KKM Architects

8th August 1996

Re 42-45 Belsize Park NW3

extract of
PROPOSED GROUND FLOOR PLAN lower level

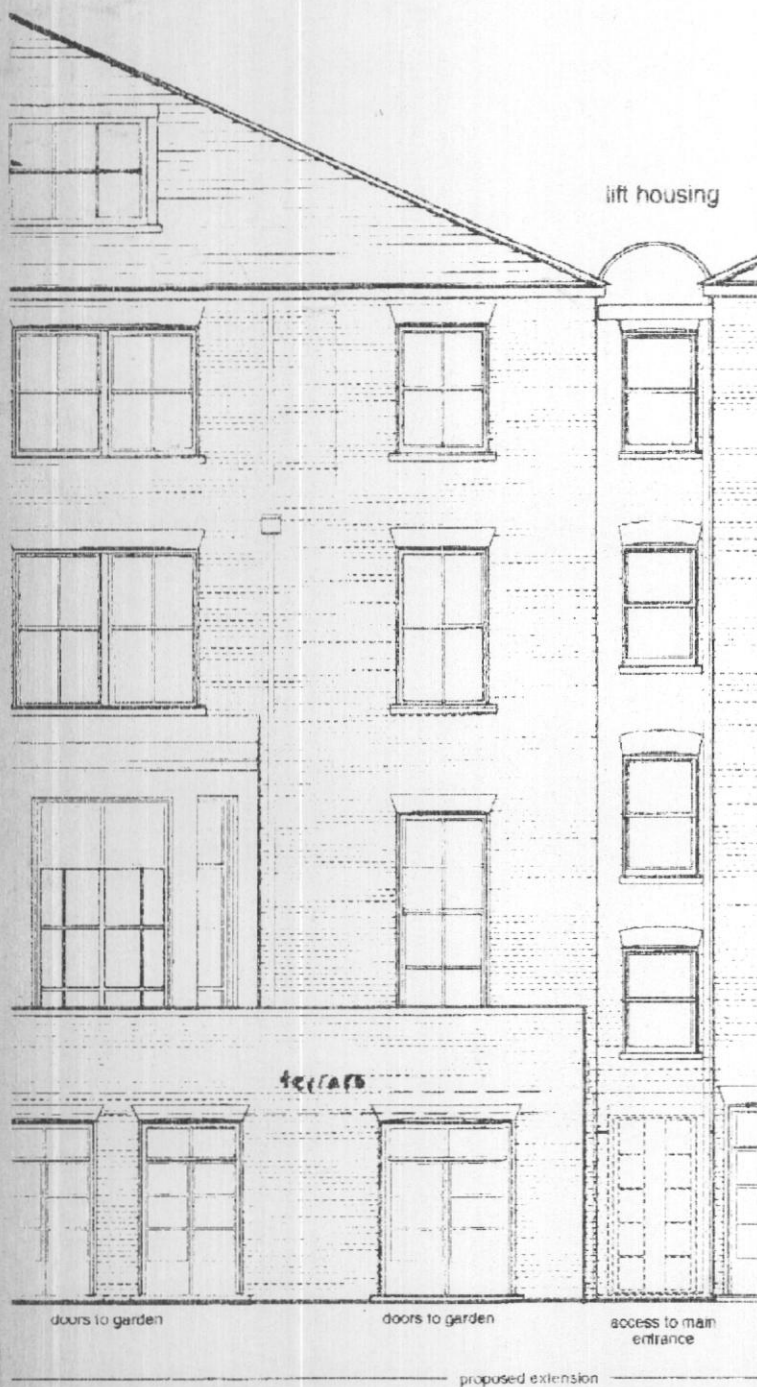
Also with reference to the terraces we note that you would like the terrace removed to Unit 6 and part of the terrace to Unit 7. Again we have shown this on the enclosed extract of the floor plan.

part rear/elevation to show height
of rear extension

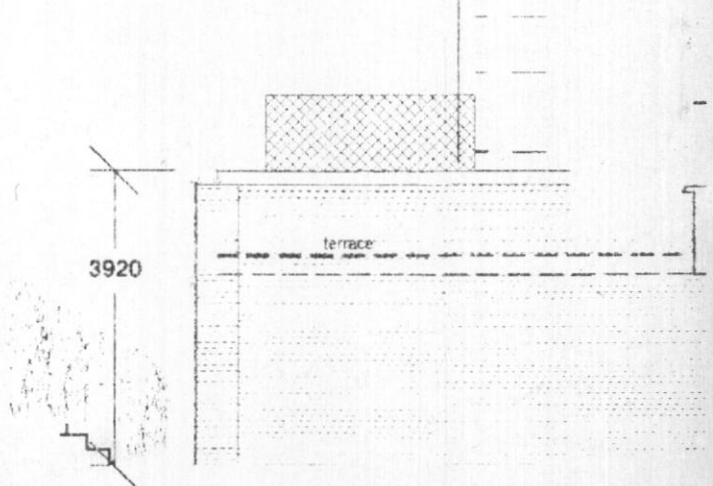
We enclose an extract of part of the rear elevation and part of the section. You will note that the rear extension height is 3920mm and the french doors to the rear elevation are reduced in height.
